Cambourne - Cambridge Bus Road (C2C) Independent Audit

Submission prepared by Colin M. Harris
25 April 2021 (v1)

This submission made to the Cambourne – Cambridge Bus Road (C2C) Independent Audit focuses on an alternative to the preferred scheme proposal by the Greater Cambridge Partnership.

Figure 1. A428 alternative C2C alignment – co-aligned with the A428 in section from Madingley Mulch to West Campus overview.

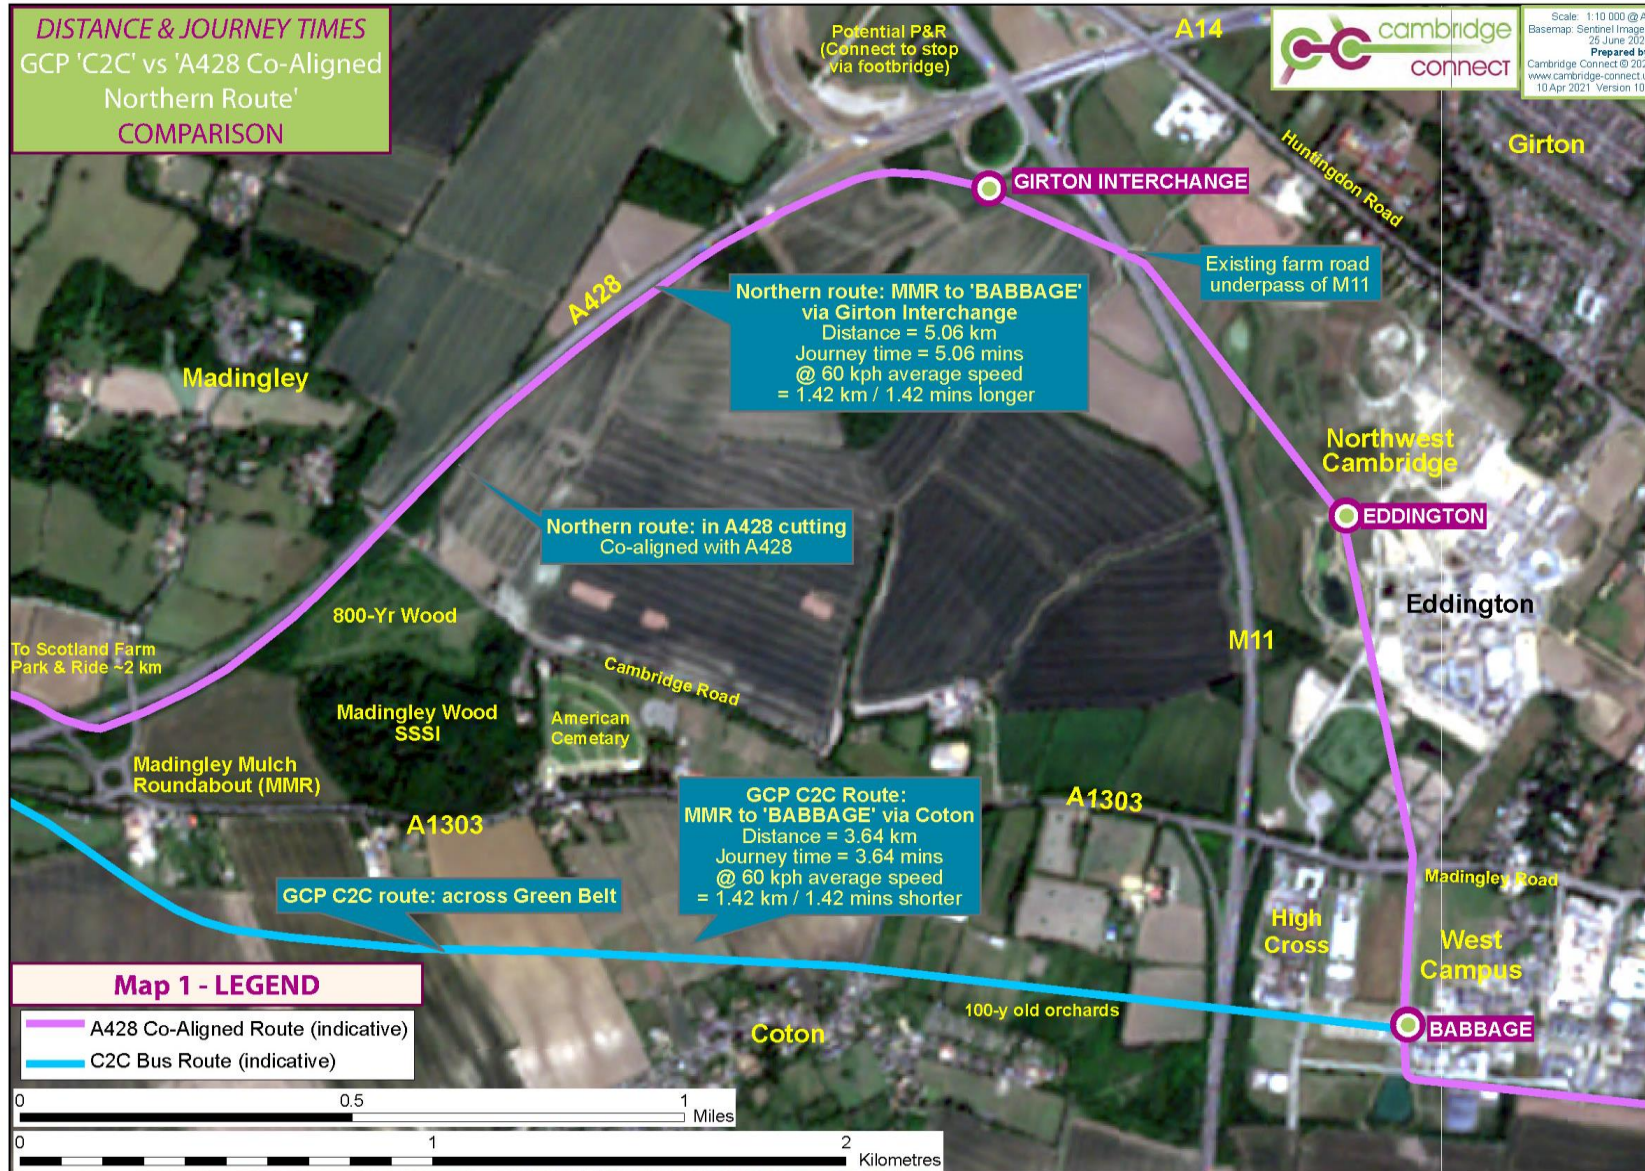
The alternative proposal is co-aligned with the A428 over a critical part of the route, and would avoid severance of, and landtake within, the Green Belt in this area (Figure 1).

- 1 Supports development of a new public transport route to the west of Cambridge following a fully segregated alignment immediately adjacent to, and co-aligned with, the A428 highway in the section between Madingley Mulch Roundabout and the Girton Interchange.

C2C INDICATIVE ALTERNATIVE ALIGNMENT
 Northern Route to Girton Interchange Co-Aligned with A428
 Alignment at Maddingley Mulch Roundabout

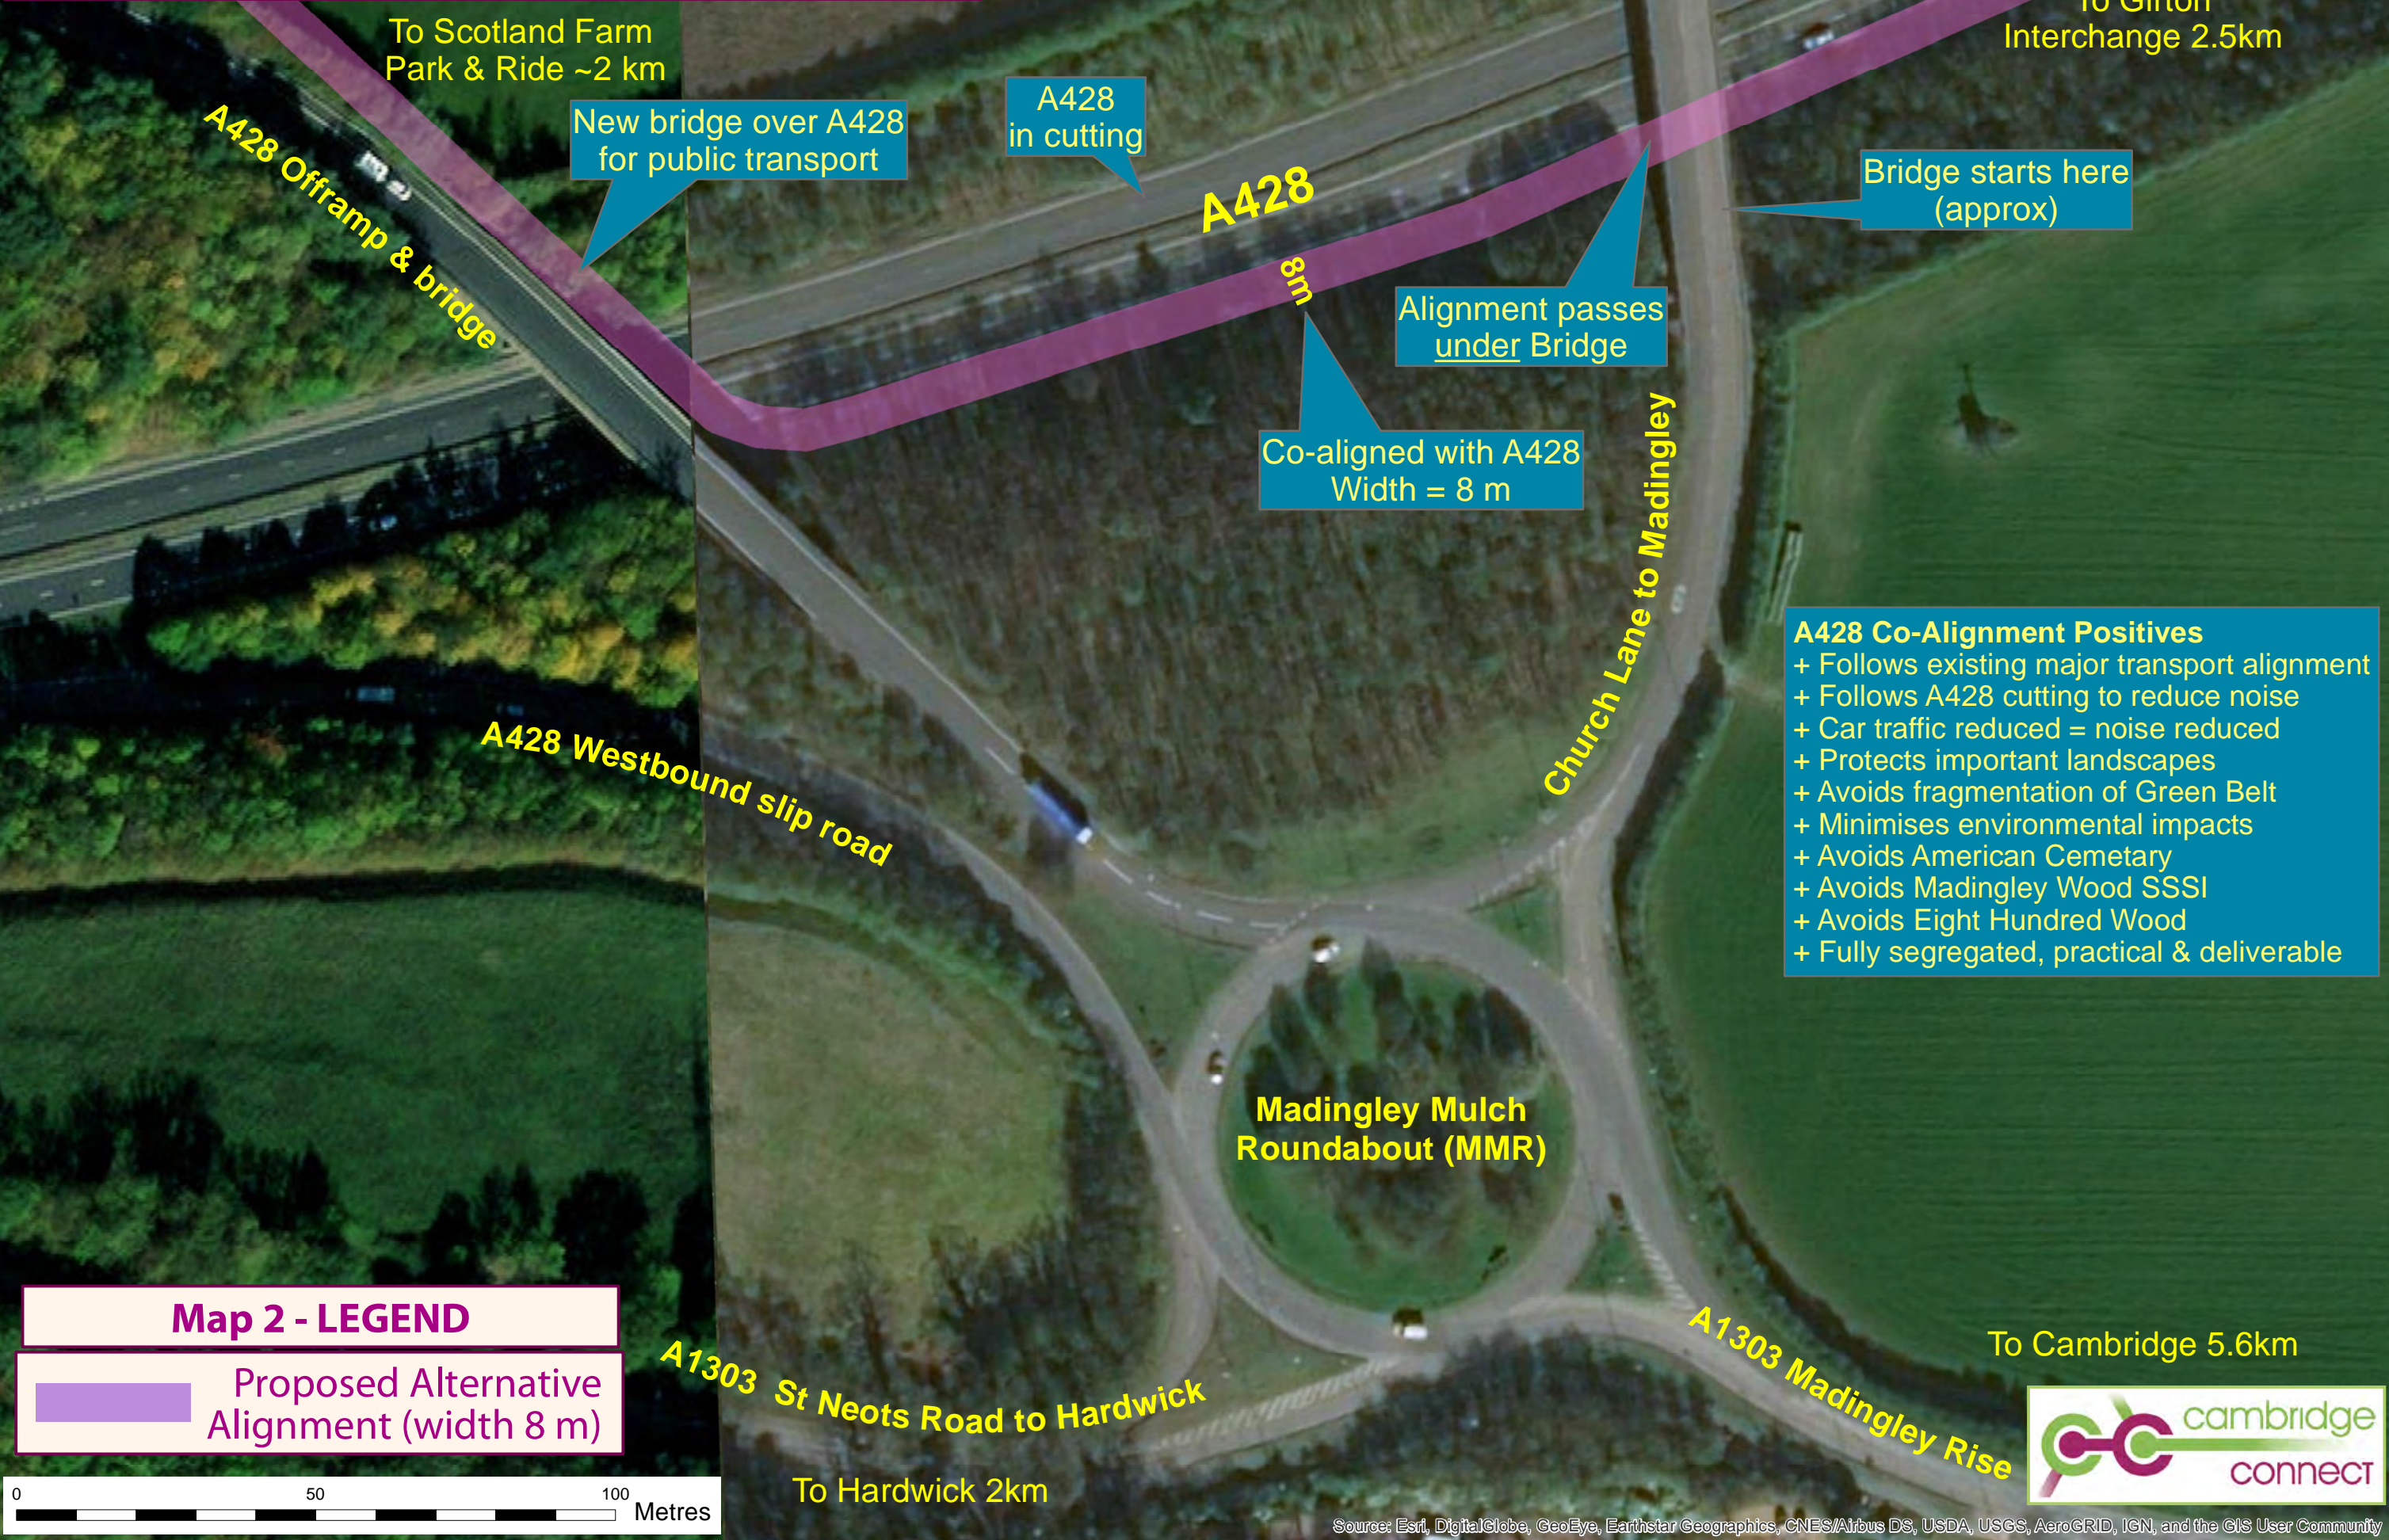
New bridge over A428 for public transport

Alignment passes under Bridge

Co-aligned with A428 Width = 8 m

- A428 Co-Alignment Positives**
- + Follows existing major transport alignment
 - + Follows A428 cutting to reduce noise
 - + Car traffic reduced = noise reduced
 - + Protects important landscapes
 - + Avoids fragmentation of Green Belt
 - + Minimises environmental impacts
 - + Avoids American Cemetary
 - + Avoids Maddingley Wood SSSI
 - + Avoids Eight Hundred Wood
 - + Fully segregated, practical & deliverable

C2C INDICATIVE ALTERNATIVE ALIGNMENT
 Northern Route to Girton Interchange Co-Aligned with A428
 Option - Co-Aligned Southeast side of A428

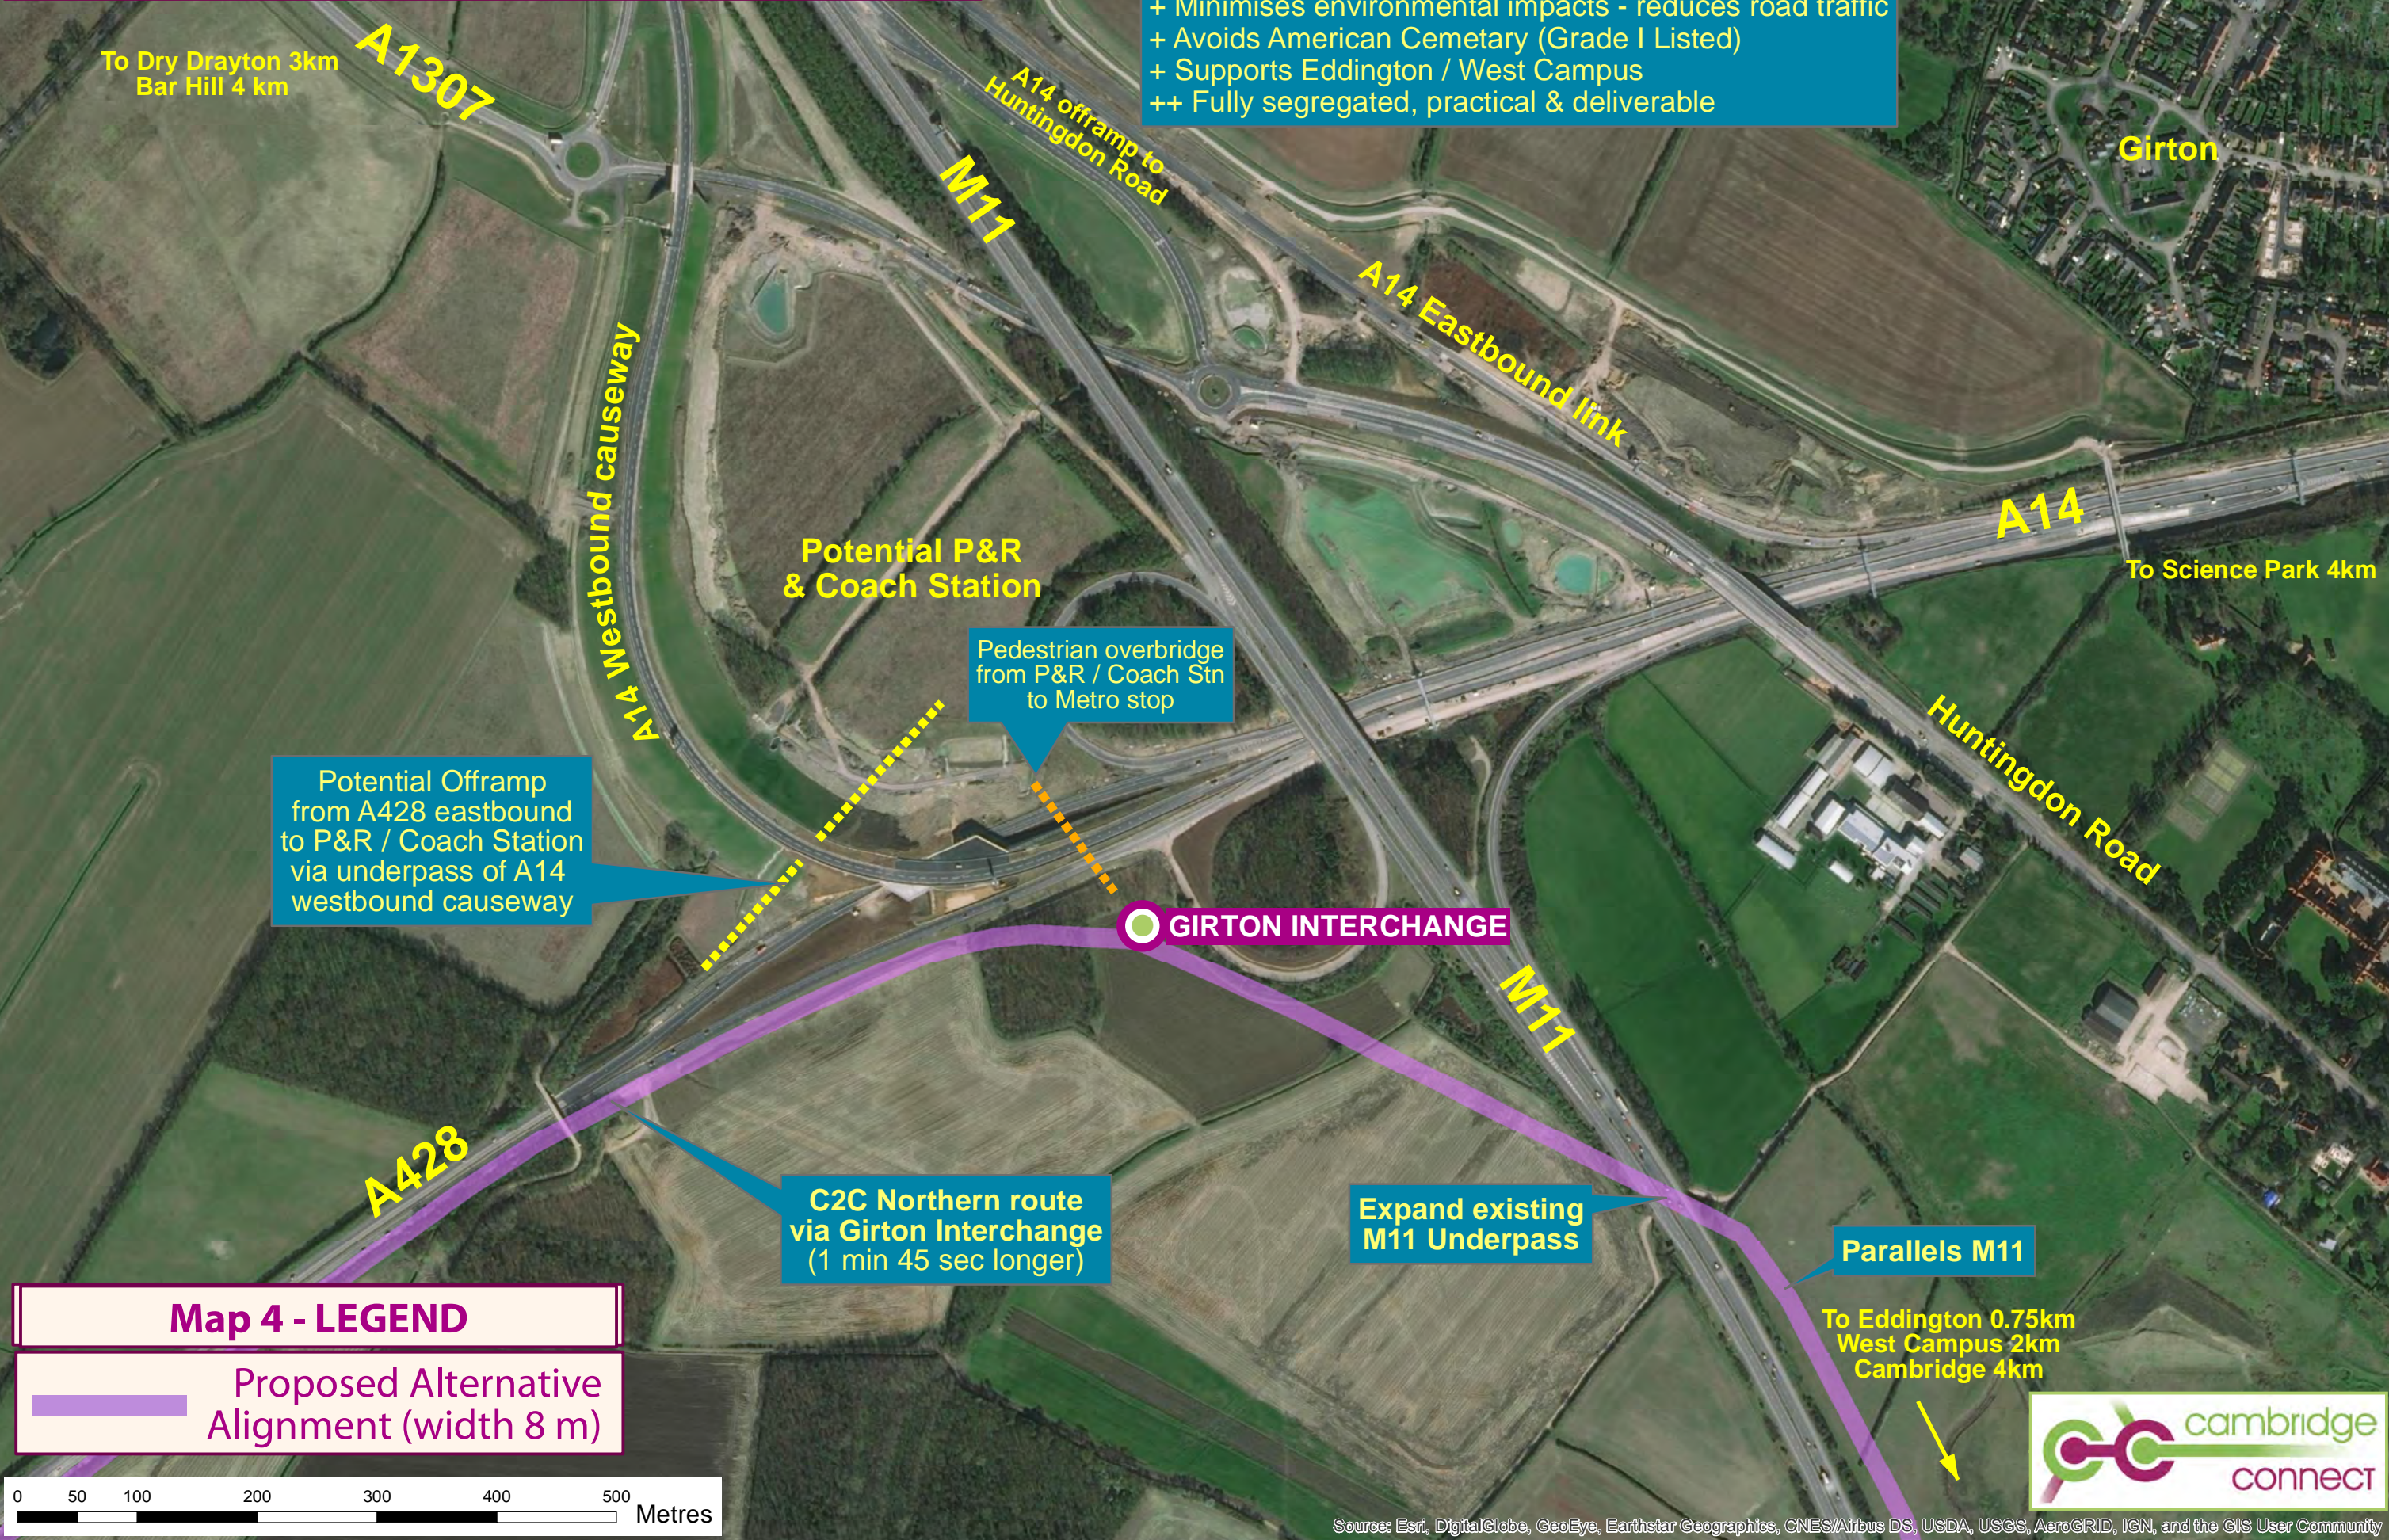
- A428 Co-Alignment Positives**
- + Strategic location future-proofed for onward links
 - + Follows existing major transport alignments
 - + Avoids fragmentation of Green Belt
 - + Minimises environmental impacts - reduces road traffic
 - + Avoids American Cemetary (Grade I Listed)
 - + Supports Eddington / West Campus
 - ++ Fully segregated, practical & deliverable

Potential Offramp from A428 eastbound to P&R / Coach Station via underpass of A14 westbound causeway

Pedestrian overbridge from P&R / Coach Stn to Metro stop

C2C Northern route via Girton Interchange (1 min 45 sec longer)

Expand existing M11 Underpass
